AGENDA
PARKS, RECREATION & NATURAL RESOURCES COMMITTEE
MEETING

To: Heather Botten, Senior Planner
From: Alanna Sobottka, Civil Engineer
McKenzie L. Cafferty, Environmental Resources Manager
Copy: Tina Goodroad, Community Development Director
Julie Stahl, Finance Director
Zach Johnson, City Engineer
David Mathews, Building Official
Date: March 11, 2025
Subject: Lord of Life Townhomes

To: Planning Commission
From: Heather Botten, Senior Planner
Date: March 11, 2025
Subject: Packet Material for the March 20, 2025 Planning Commission Meeting

To: Planning Commission
From: Heather Botten, Senior Planner
Date: March 11, 2025
Subject: Packet Material for the March 20, 2025 Planning Commission Meeting
Agenda Item: Pumpkin Creek Preliminary plat and Zoning Map Amendment
Action Deadline: April 8, 2025

L100

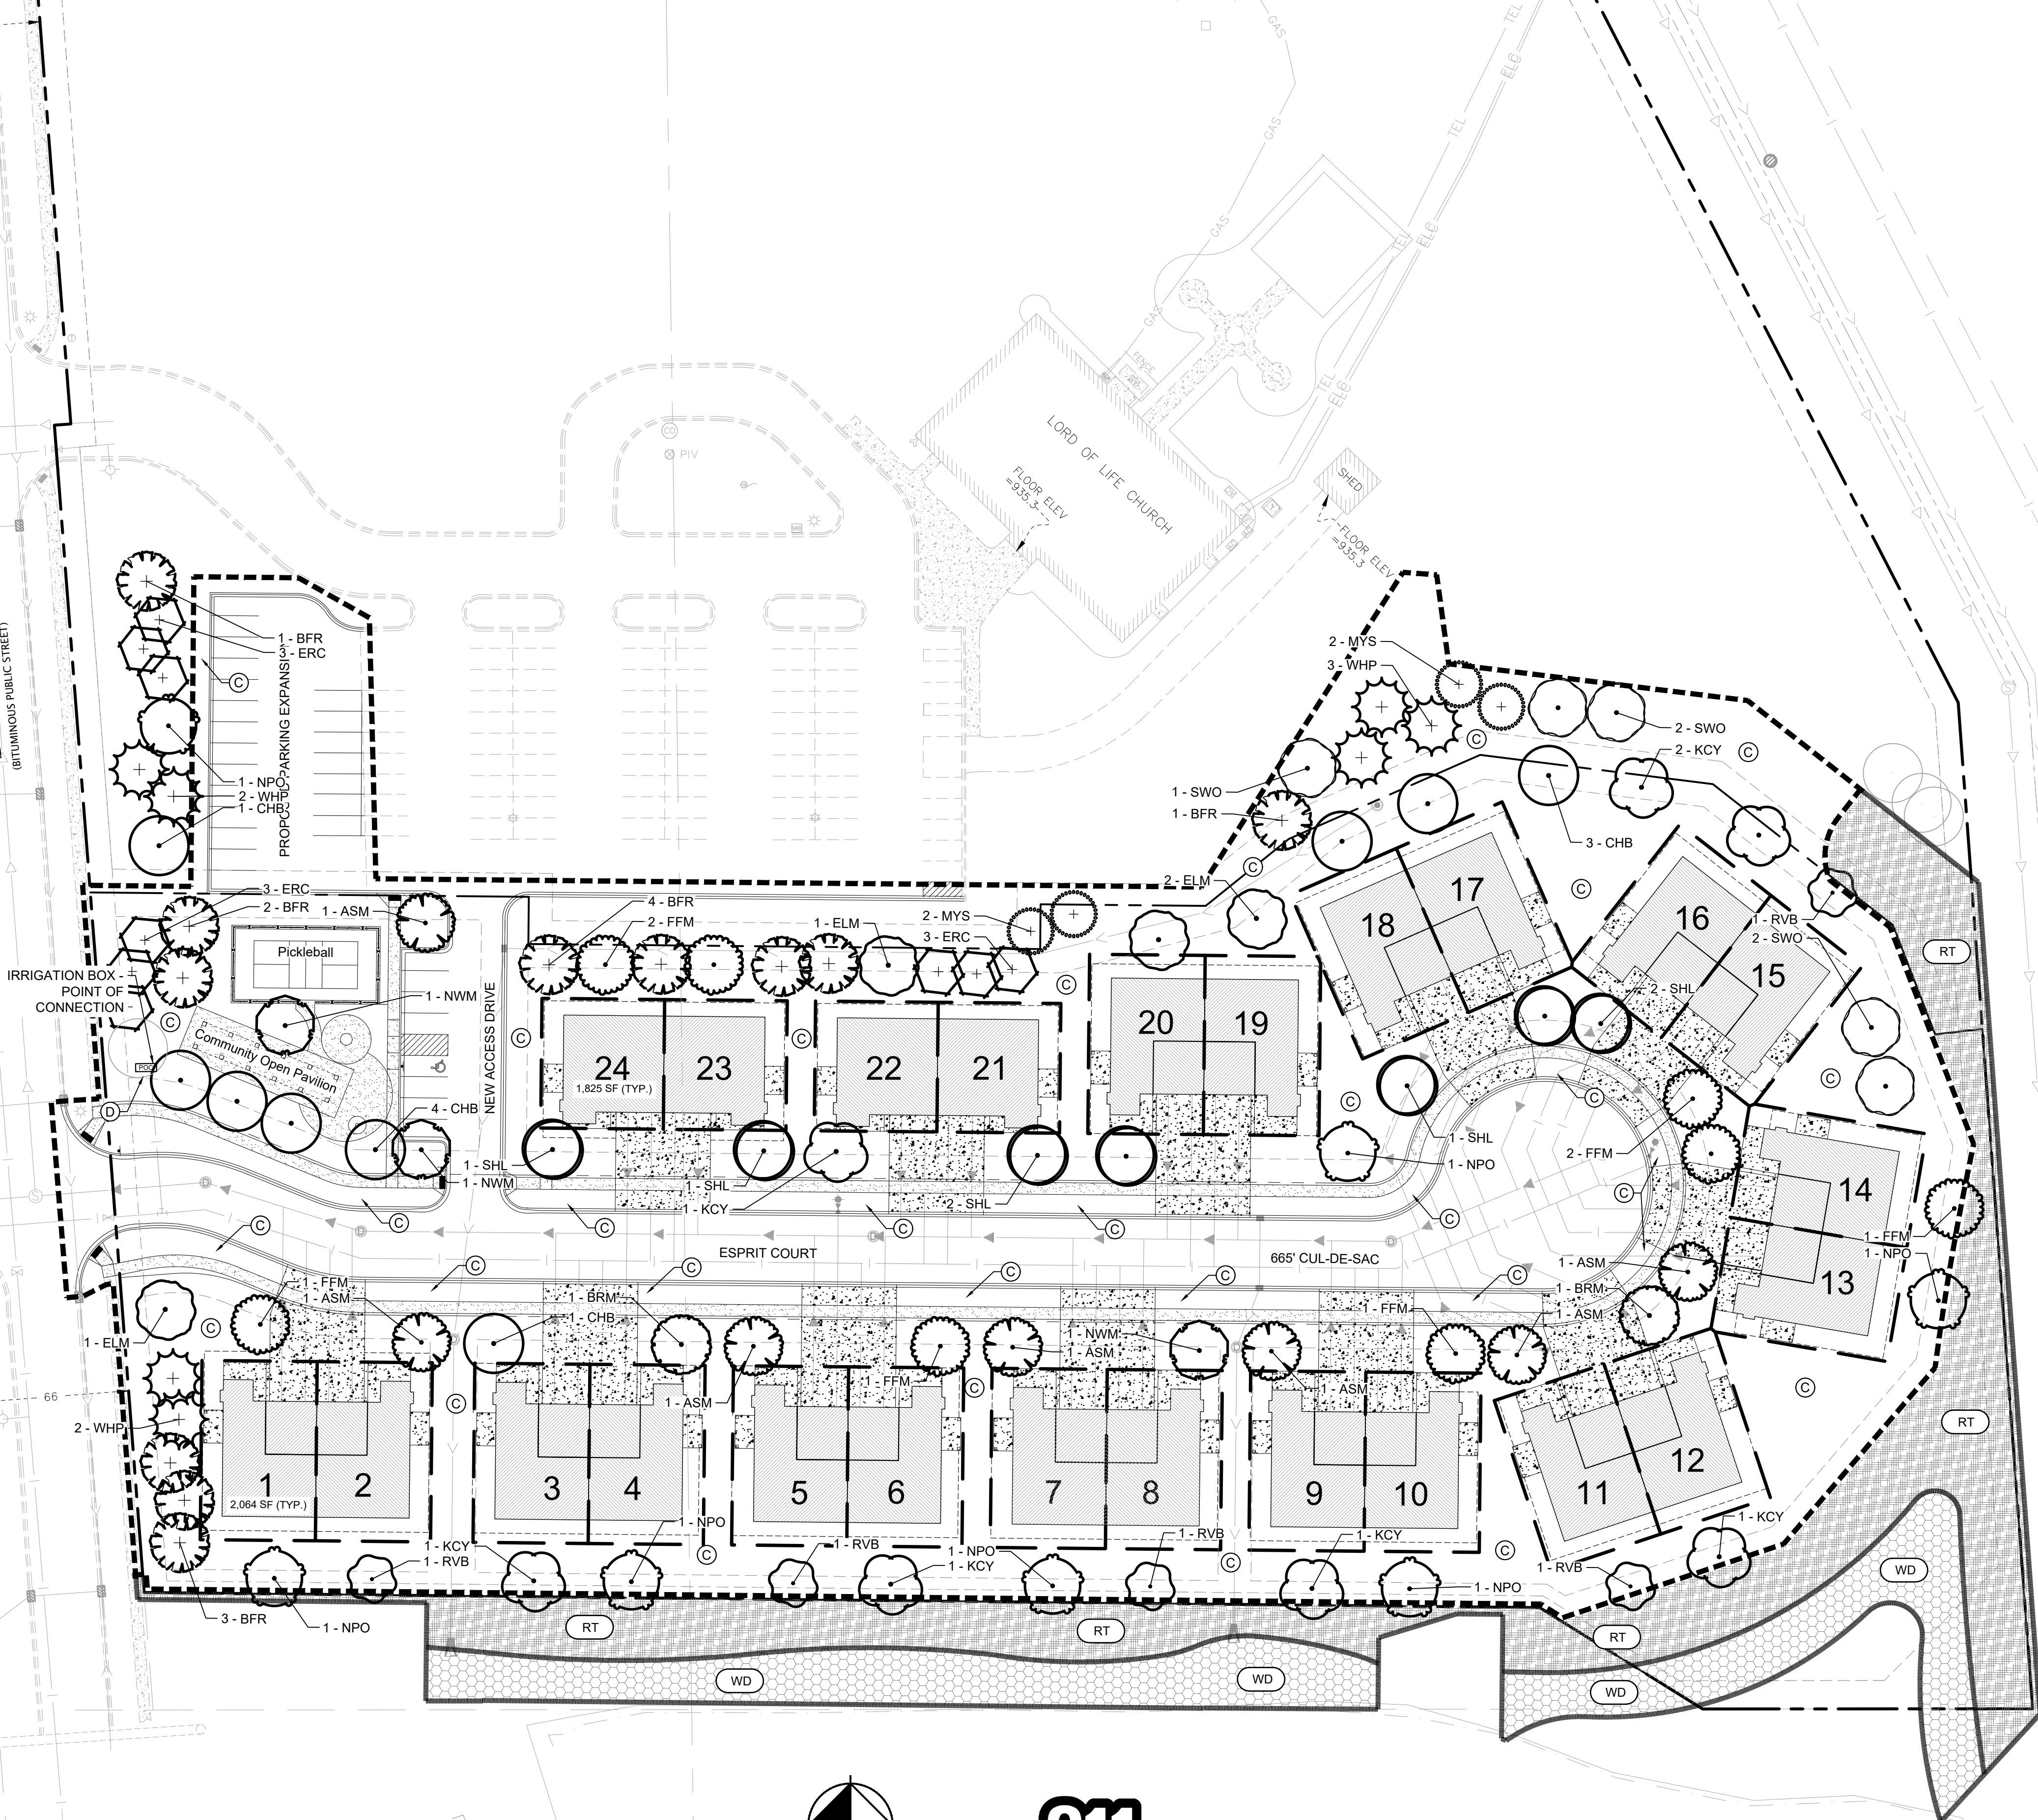
The plan identifies 4 significant trees on-site to be removed. The landscape trees along Dodd Lane will remain and will require tree protection fence be installed around them prior to grading activity.

The landscape plan shall be amended to identify minimum shrub sizes, not plant pot size. Low growing shrubs shall be 18 to 24 inches and tall growing shrubs shall be 24 to 36 inches as required by Section 11-21-9 of the Zoning Ordinance.

3. The twin home dwellings must demonstrate compliance with Zoning Ordinance requirements of Section 11-57-19 at the time of building permit issuance.
4. The landscape plan shall be revised to identify minimum shrub sizes, not plant pot size. Low growing shrubs shall be 18-24 inches tall and tall growing shrubs shall be 24-36 inches tall as required by Section 11-21-9 of the Zoning Ordinance. The developer shall provide details to verify compliance with the landscape requirements of Section 11-57-19 of the Zoning Ordinance.
